Planning Commission

**Agenda**

# PLANNING COMMISSION REPORT

APPLICATION FOR SITE PLAN APPROVAL AT  
1636 HAYES AVE. PARCEL (57-05666.000)

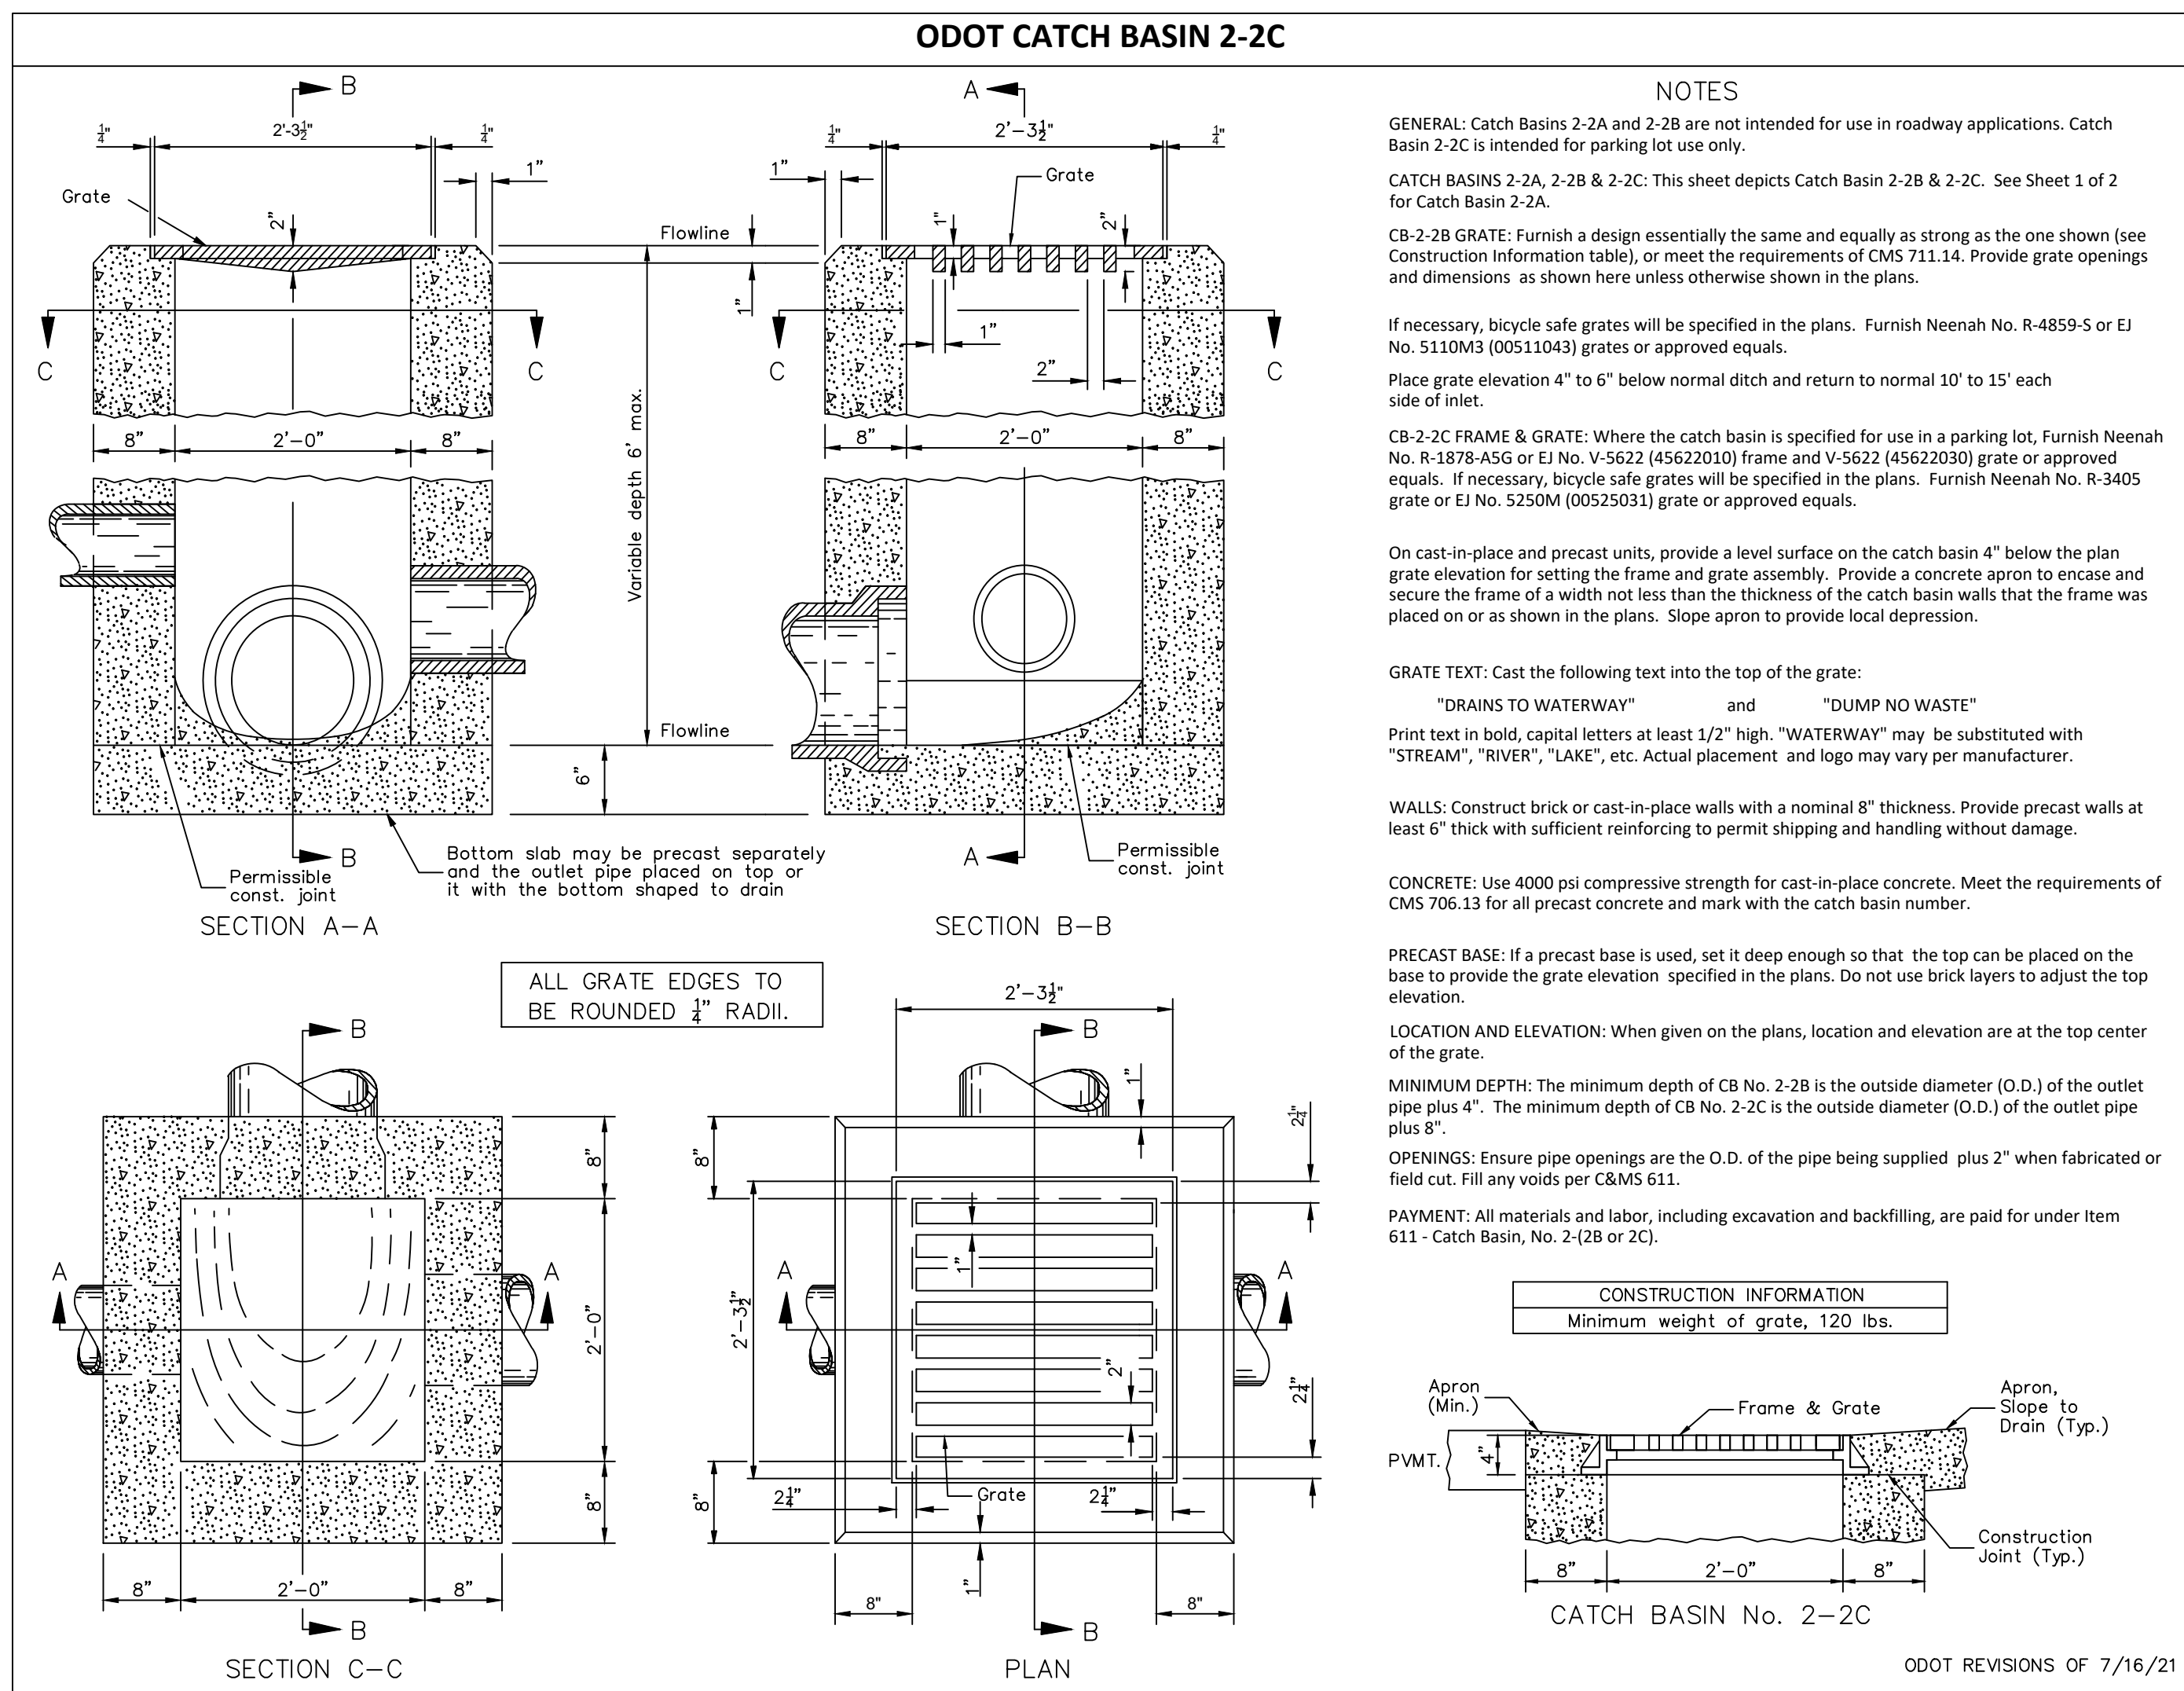
According to the requirements in Section 1149.04 of the Zoning Code, Measurement Standards (c) “Storage or warehousing may be waived with administrative approval and if not approved by the administration, the Planning Commission may approve the waiver”. Staff recommends waiving any parking requirements. However, the code still requires all access driveways be paved.

With no additional parking requirements, no additional landscaping is required. In general, staff recommends adding trees as part of any site-plan improvement, in this case adjacent to Hayes Ave. to beautify the site.

Engineering has noted: There is a need to re-work stormwater drainage, reduce pipe outlet size 6” max, “bowl” out areas around catch basins, stone swales leading to catch basins. On 3.20.24, Engineering stated they were satisfied with the updated plans restricting the storm outlet from the added paved site. No further concerns.

The Building Department would like applicant to combine the parcel to the east (parcel 57-05665.001) to the parcel in this application (parcel 57-05666.000). Per code, an access point to the site may not be on a separate parcel. No further concerns.

1. All applicable permits are obtained through the Building Department, Engineering Department, Division of Planning and any other applicable agency prior to construction.
2. Parcel 57-05665.001 and the parcel 57-05666.000 are combined prior to construction.
